# Sheringham Shoal and Dudgeon Offshore Wind Farm Extension Projects

In-Principle Cromer Shoal Chalk Beds (CSCB) Marine  
Conservation Zone (MCZ) Measures of Equivalent Environmental  
Benefit (MEEB) Plan (Revision B) - Tracked Changes Version

February 2023

Document Reference: 5.7.1.1

Figure 8.1 The proposed initial 1km<sup>2</sup> (light blue polygon) native oyster restoration site search area and the indicative size of the 10,000m<sup>2</sup> restored reef (red square within blue polygon) in the north-western section of the CSCB MCZ

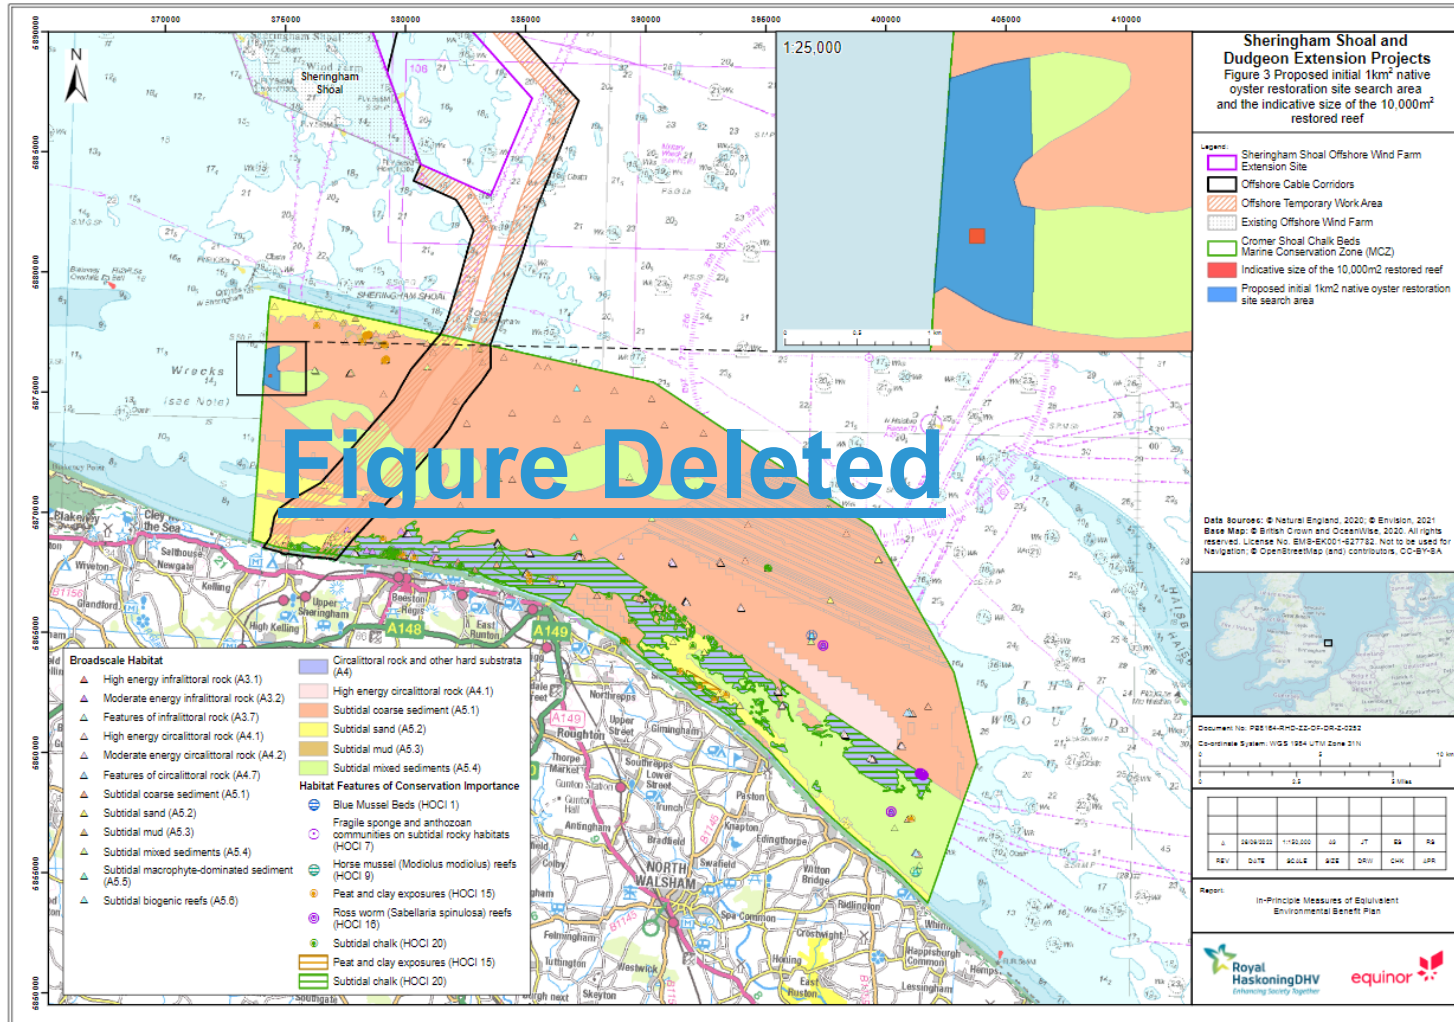
- [Figure 8.1 updated to address comment from Natural England ‘\*Natural England therefore advises against the placement of cultch and restoration of an Oyster bed in the middle of a mixed sediment area. For this to be considered as additionality we advise that it would be better to extend/enhance the area of the mixed sediment on the boundary with impoverished coarse sediment e.g. in the centre of the ‘c’ shaped mixed sediment area or north/south of the blue rectangle\*’;](#)

Section 7.2	<p>Natural England advises that the location of the oyster bed within the Cromer Shoal MCZ can be agreed now and should be located where there is indication of a previous bed. Please see Figure 1. Therefore, the area of search post consent can be targeted and experts could be brought in now to outline how to restore an Oyster bed in this location.</p>	<p>Annex C provides a site selection exercise which has identified a location in the north west of the MCZ as being suitable for native oyster bed restoration (<b>Figure 8.1 of the In-Principle MEEB Plan</b>). This area correlates well with the area proposed by Natural England.</p>
